STATE OF HAWAII
DEPARTMENT OF TRANSPORTATION
HIGHWAYS DIVISION

SPRINKLER PLAN
PACKAGE NO. 2

PEARL HARBOR INTERCHANGE
F.A.I. PROJ. NO. I-H-1(11)14

SCHEMATIC WIRING DIAGRAM

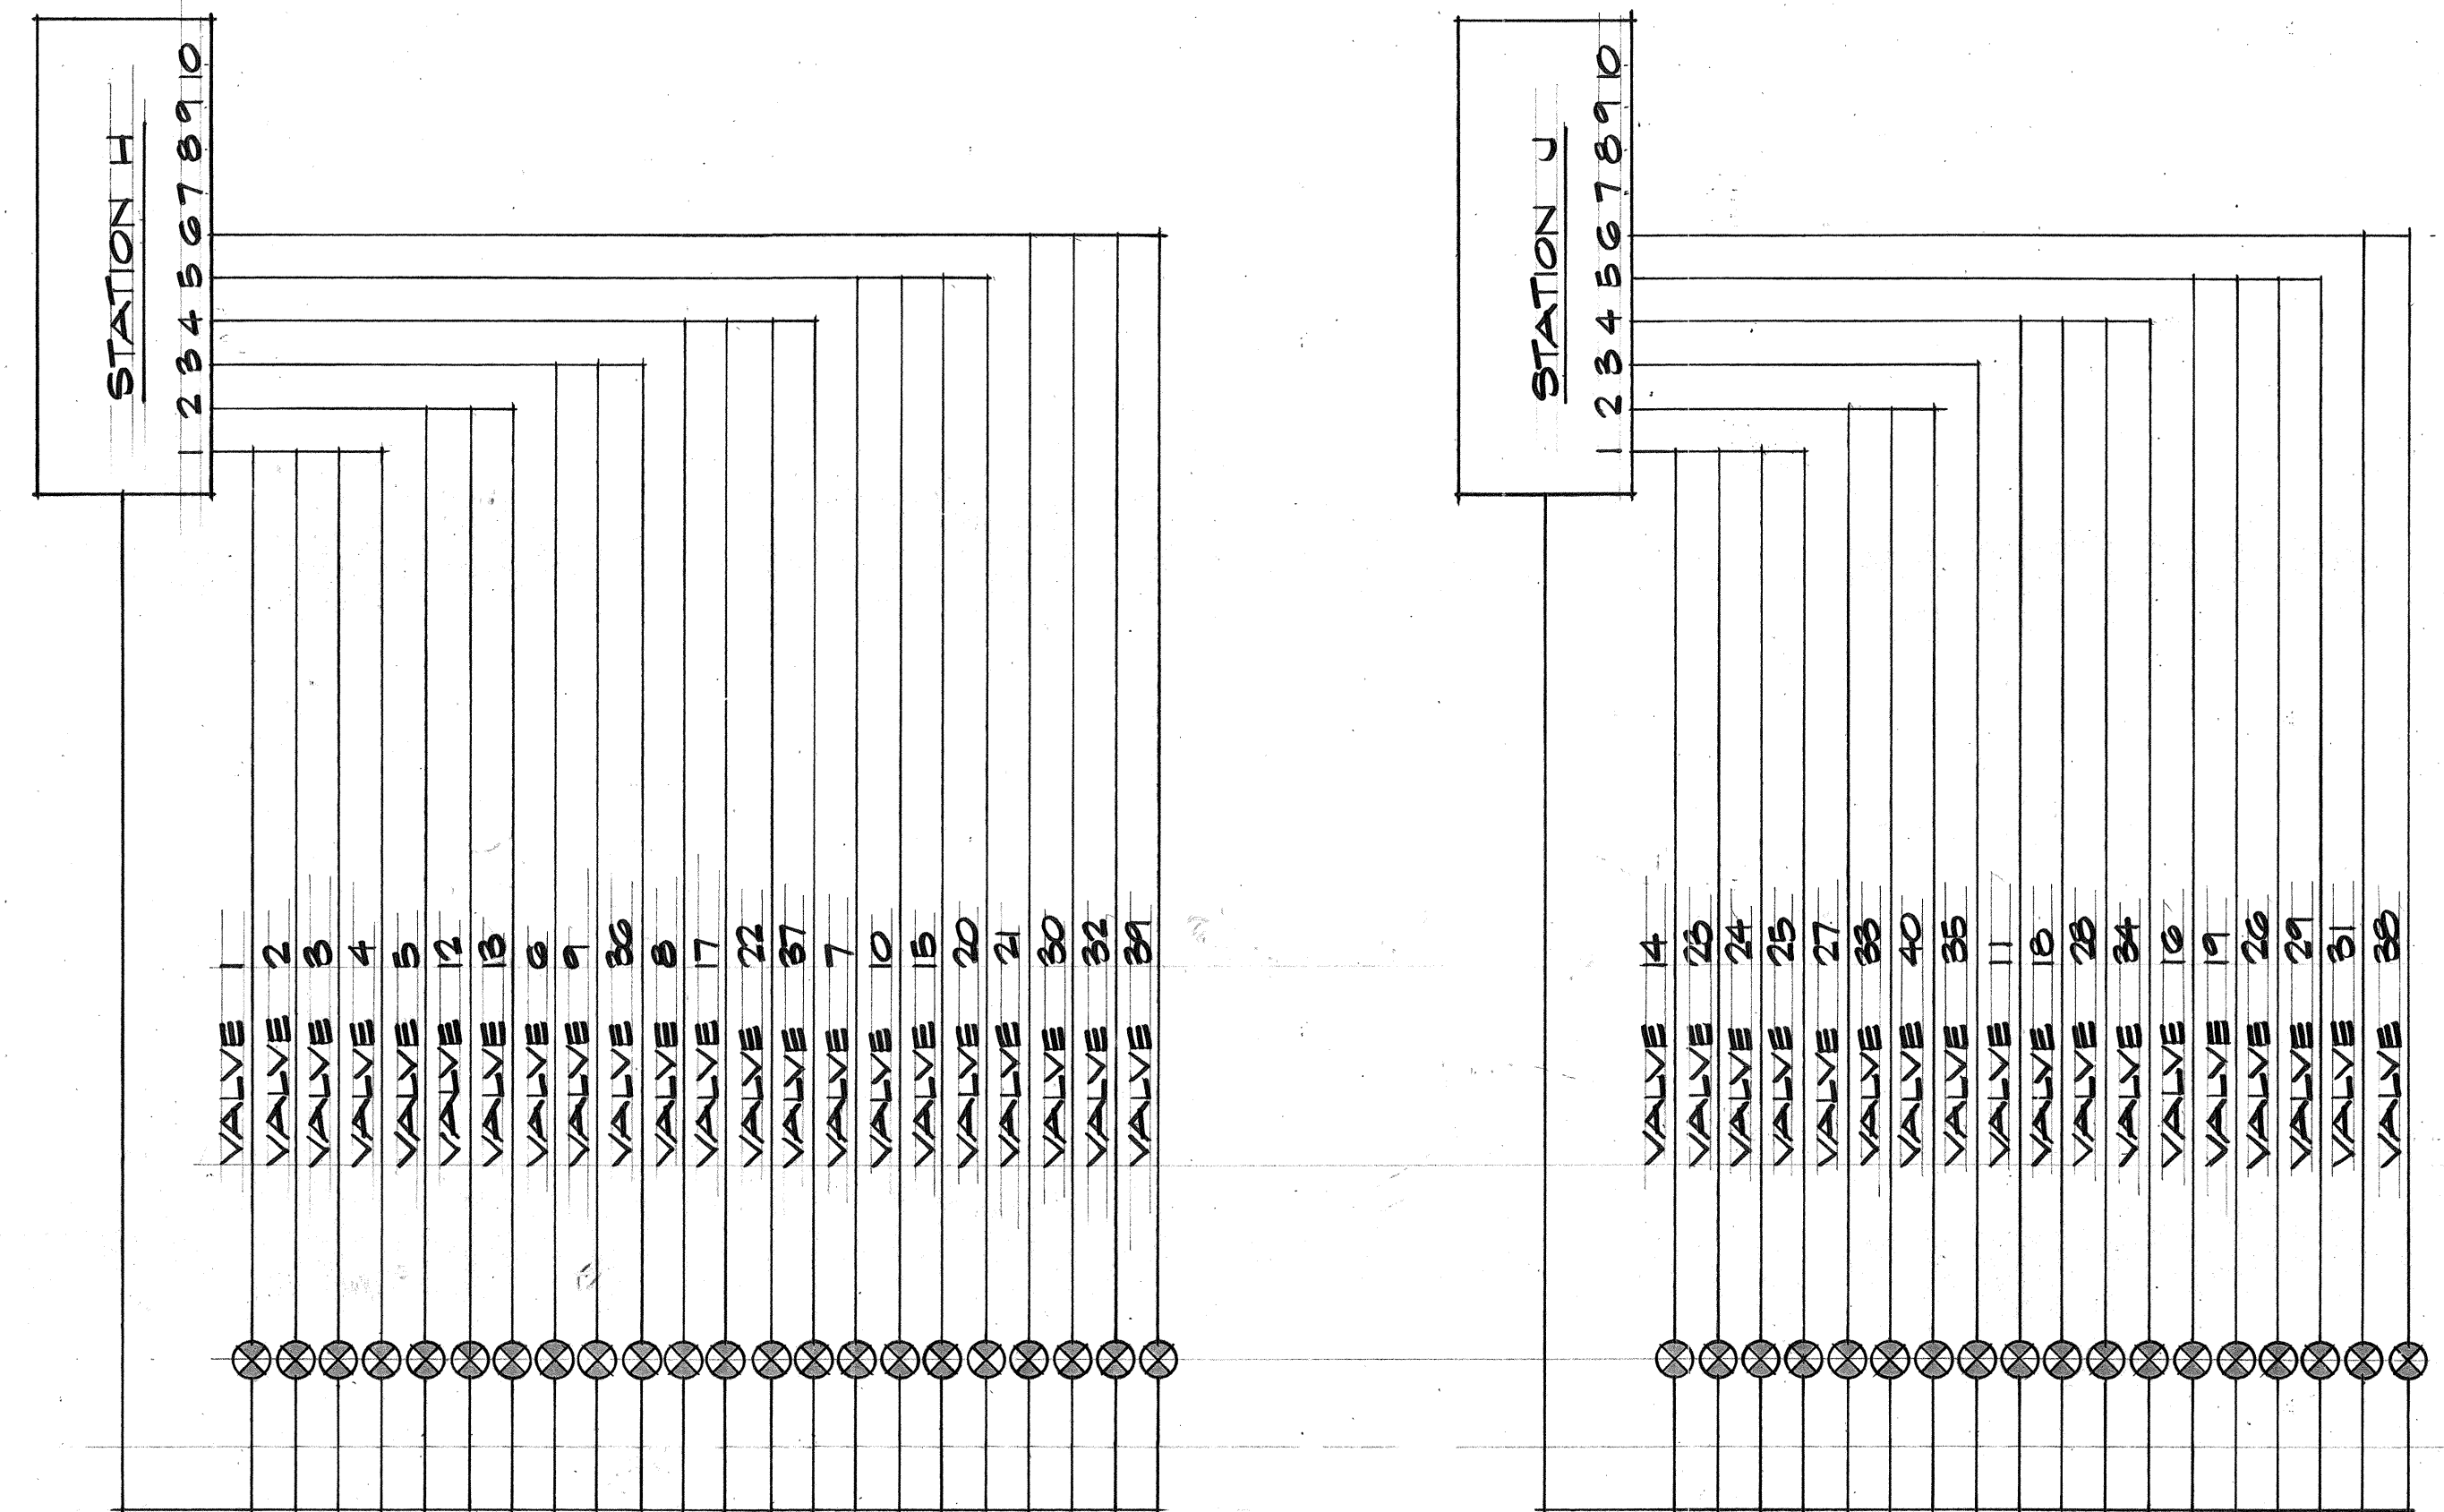
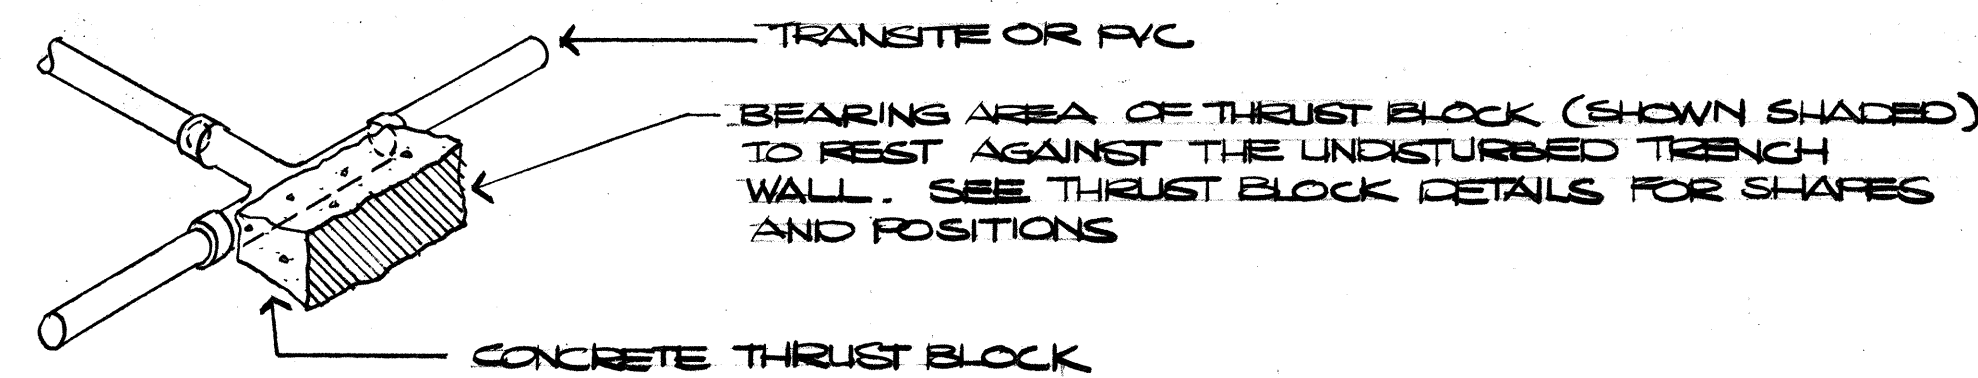
Field Directive
Feb. 5, 1976

All automatic sprinkler
system controllers shall
be set to operate only
between 8:00 a.m. and 3:30 p.m.
